STAFF RECOMMENDATION
1329 Seventh Avenue North
May 20, 2015

Application: Demolition; New construction—infill
District: Germantown Historic Preservation Zoning Overlay
Council District: 19
Map and Parcel Number: 08112044100
Applicant: Manuel Zeitlin
Project Lead: Melissa Baldock, melissa.baldock@nashville.gov

1 LEVEL 1 SCHEMATIC PLAN
1/16" = 1'-0"

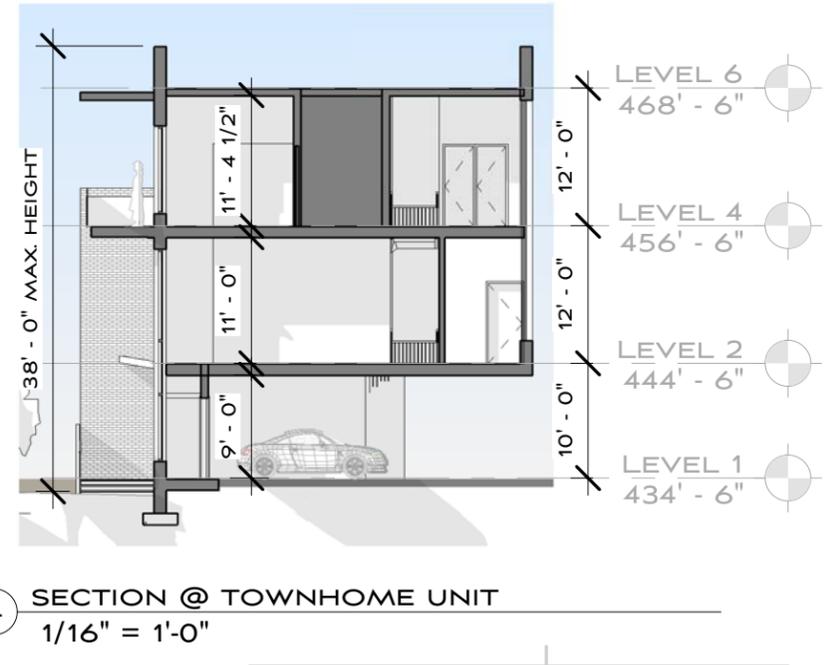
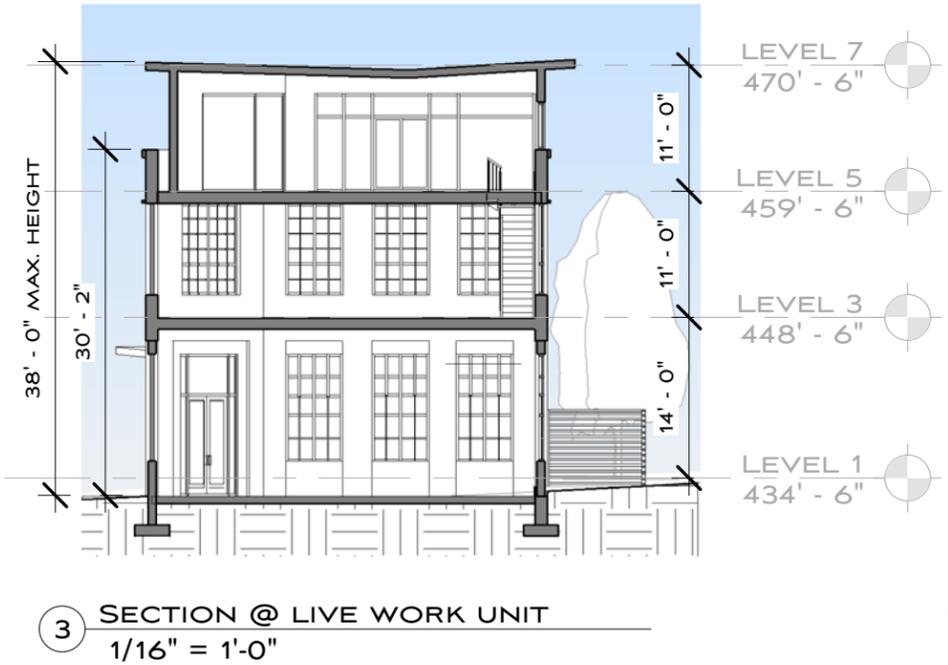
Paving/Driveways/Parking Areas: Parking for the site will largely be accommodated on the interior of the lot and will not be visible from the street. No new curb cuts will be added on either Seventh Avenue North or Taylor Street, and vehicular entry to the site will be from the alley. The site plan shows two parking spaces at the corner of Taylor Street and the alley, which will be visible, but are appropriate because they are located at the rear of the site at the alley. In addition, they are screened with a railing and bike parking.

The drawings shown optional parking within unit 5, which if implemented would mean that the windows would open into a garage rather than living space as only four feet (4') usable space would be left over with the potential of being finished conditioned space. Staff does not recommend that parking be on the ground floor without being screened with conditioned space as it does not meet the intent of sections 5.3.3 and 4 which require that parking structures be located behind or below buildings and that parking structures close to the sidewalk include retail uses at the ground level to engage the pedestrian network. Although this is not a large parking structure, the result of a disengagement from the pedestrian network is the same.

With the condition that the ground floor of unit 5 be conditioned space, rather than parking, Staff finds that the development's parking meets Section 5.3 of the design guidelines.

- There be no parking on the inside of unit 5; and,
